3036661-EG / 3036556-LU
RECOMMENDATION PACKET
ADMINISTRATIVE DESIGN REVIEW
JANUARY 20TH, 2022

LITTLEFIELD APARTMENTS ANNEX
1820 E JOHN ST

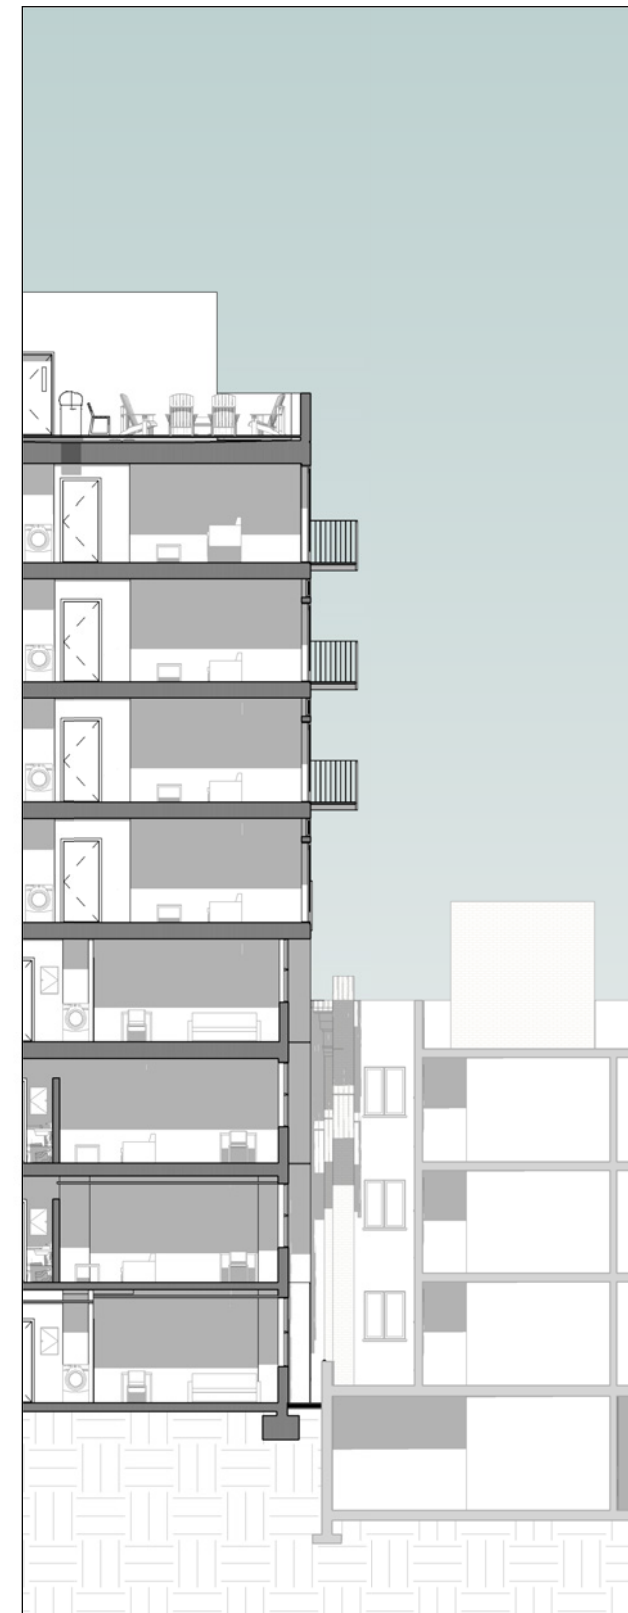
4e. Staff continues to be concerned with the large blank façade proposed on the west elevation. Utilize high quality materials and design treatments which provide texture and visual interest. The treatment of this façade will be considered in reviewing related departure requests.

Response: The west tower and base now have a strong fenestration pattern that adds interest to the exterior, allow natural light into the corridor and balance privacy concerns with the adjacent building. Infill/spandrel panels have been added to group windows, tying into the John St. façade. The color of the west façade has been lightened to allow more light reflection and contrast with the spandrel panels on this façade. Brick has been further extend onto the brick facade at the base. Board and batten siding and window groupings add further interest and texture to the tower. See rendered perspectives on pages 35 and 50. See rendered elevation on page 26. (DC2-B-2, DC2-B-1)

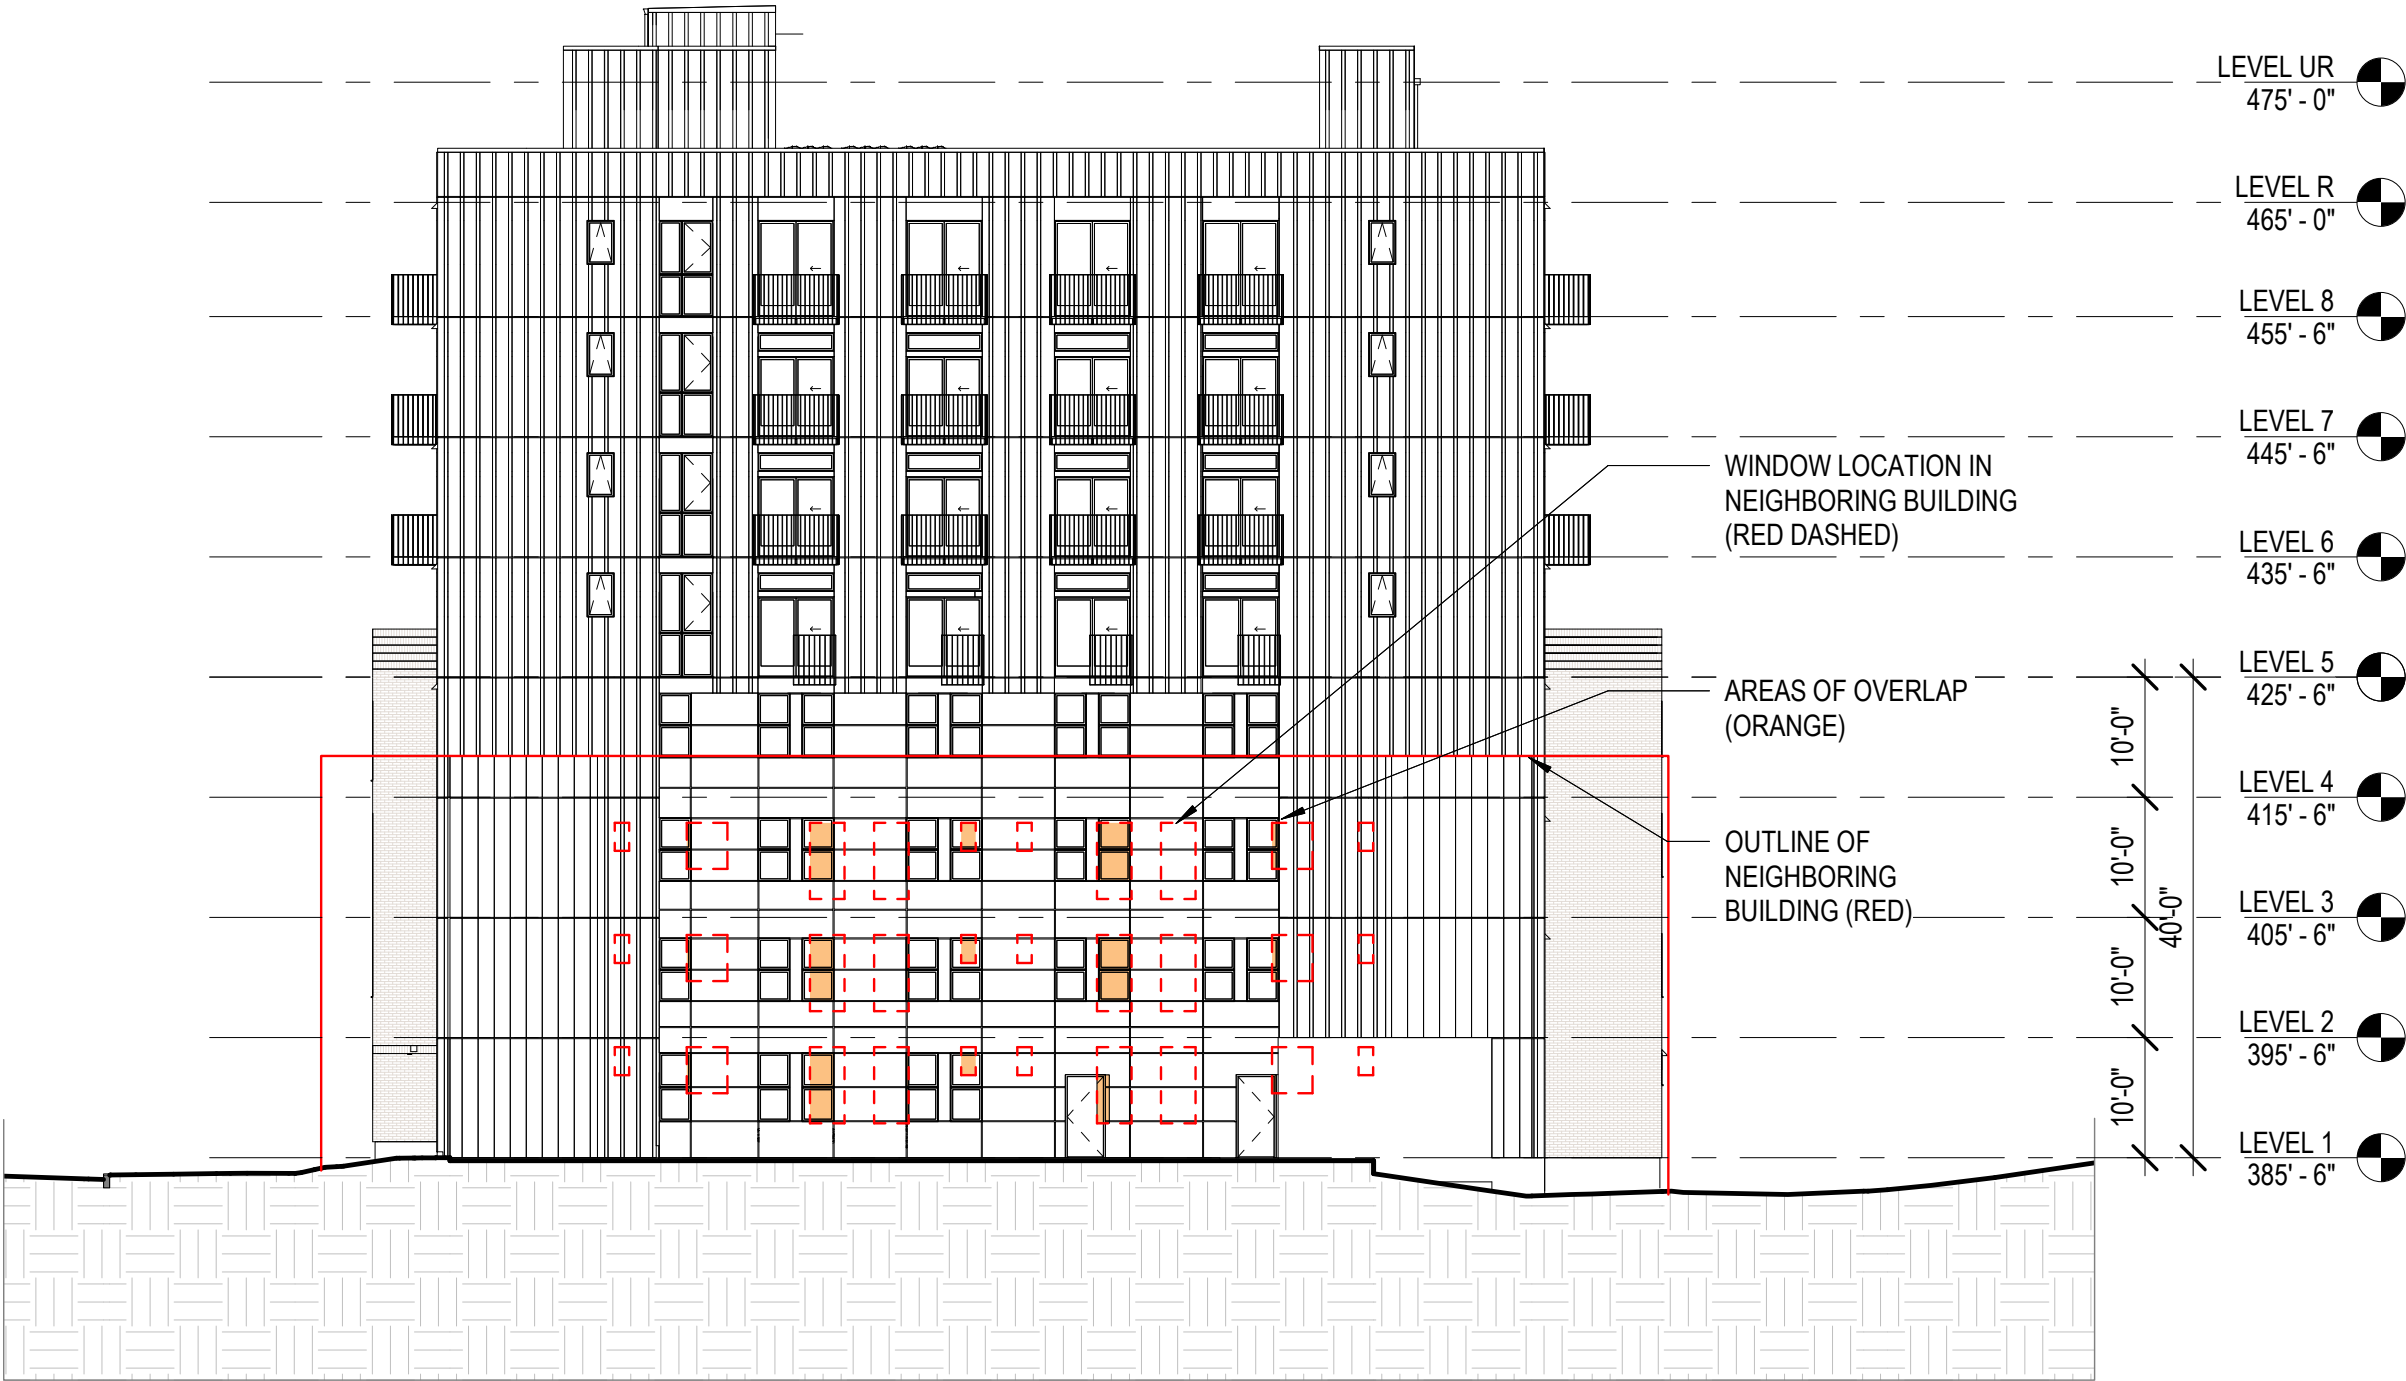
2b. Develop the small landscape area along the west property line to provide a buffer to mitigate privacy concerns.

Response: See adjacent section this page. Also refer to the landscape plan on page 54. Taller plantings have been added to the biplanter in order to buffer the adjacent property. (CS2-D-5)

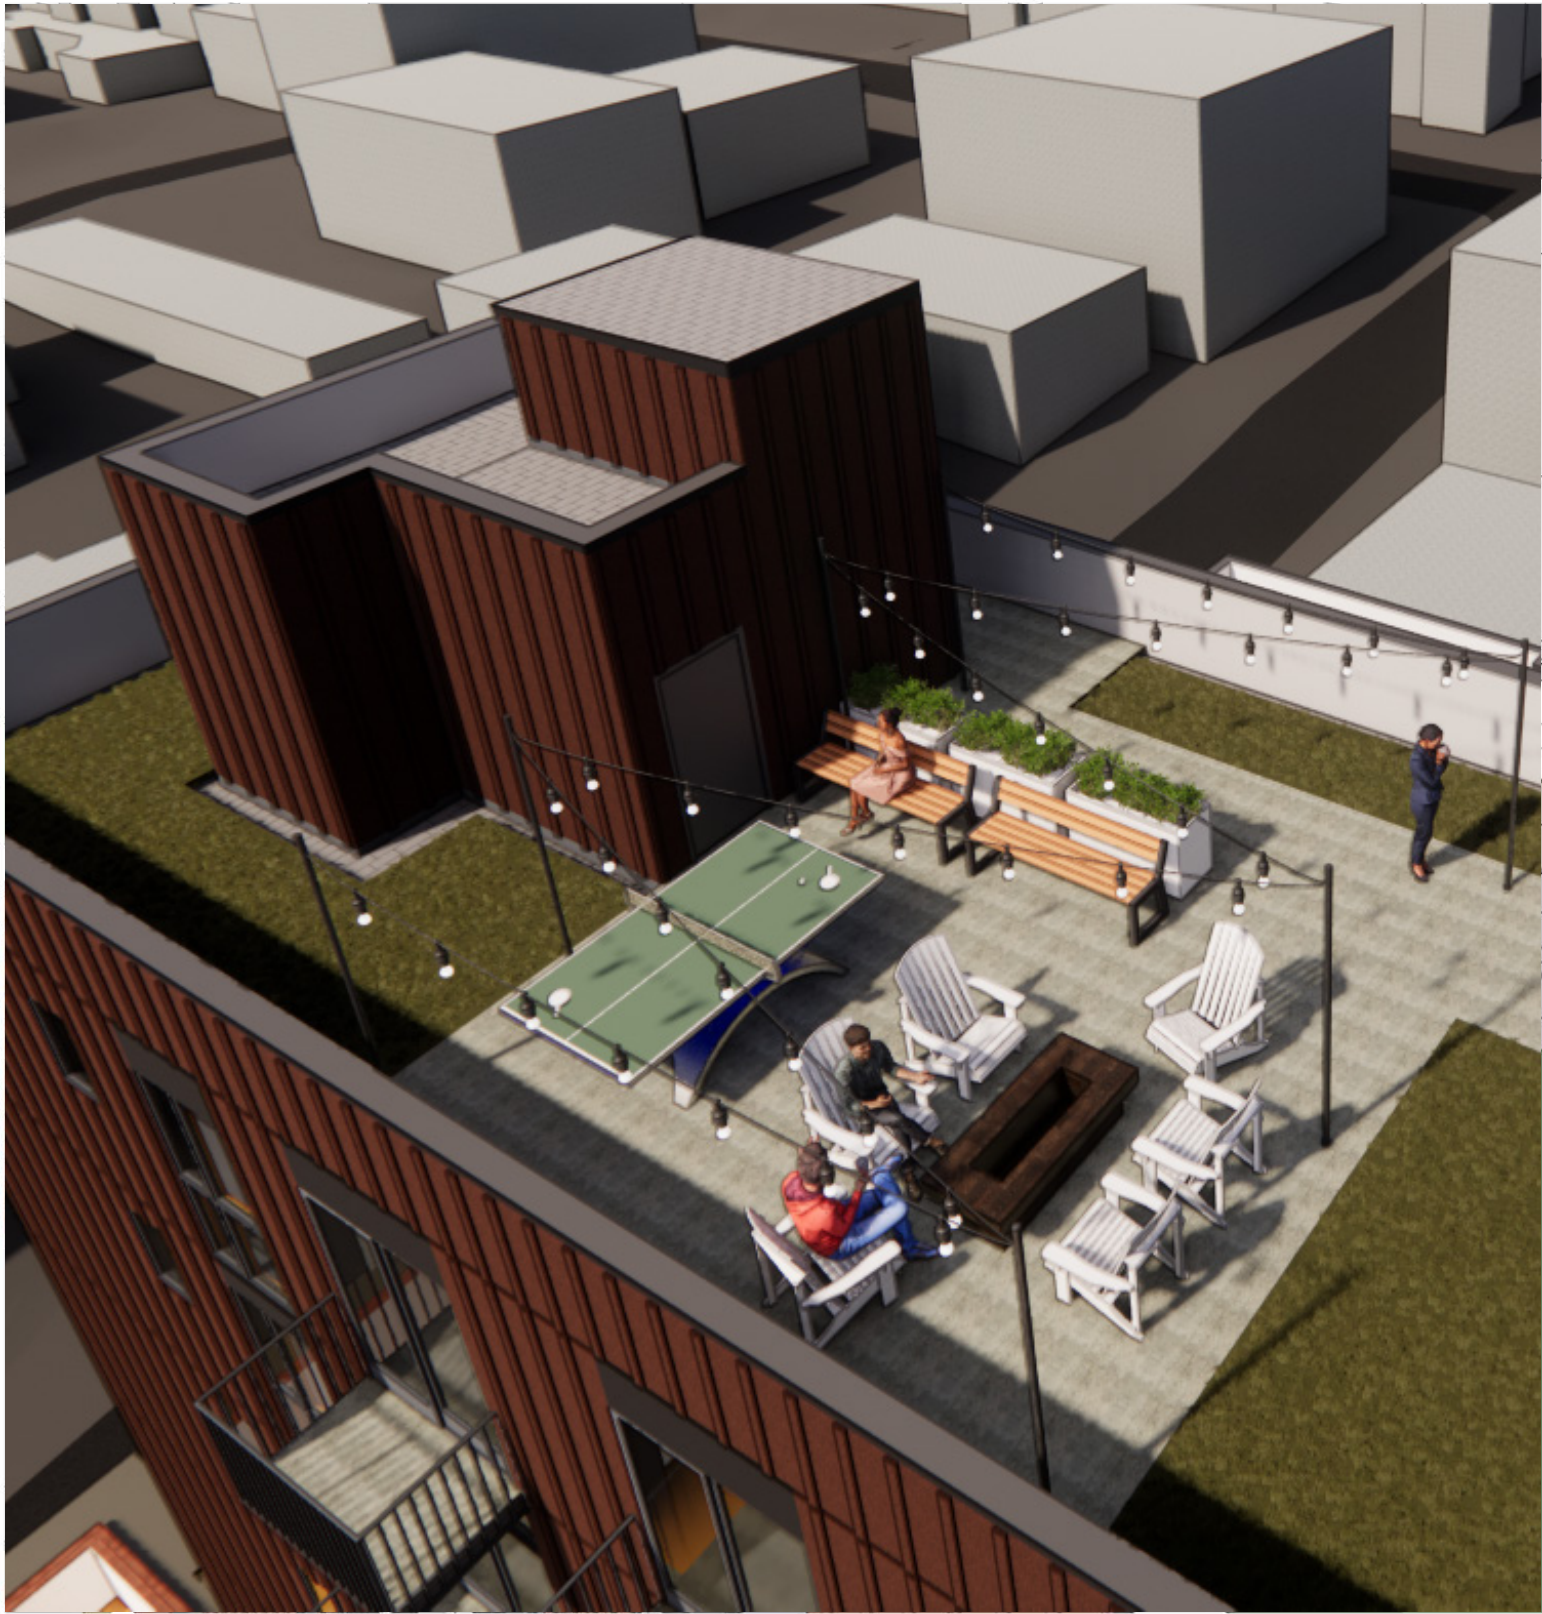
4. Structure Depth. (23.45.528.B.1). The Code requires that the depth of principal structures shall not exceed 80 percent of the depth of the lot. The applicant proposes to increase the structure depth to 95.1% of the depth of the lot in Option D. Staff is initially supportive of the departure request if guidance related to developing a legible base level is adequately addressed as the reduced setback allows for retention of the historic structure.

Response: Guidance related to developing the podium has been followed and developed. Revisions to the design include: an increase from three to four levels at the podium and an increase in the setback from the podium and tower south faces. See sidewalk perspective this page. See also perspectives and sections on pages 42 and 28 & 34, respectively. (CS3-A, DC2-1, CS3-A-1)
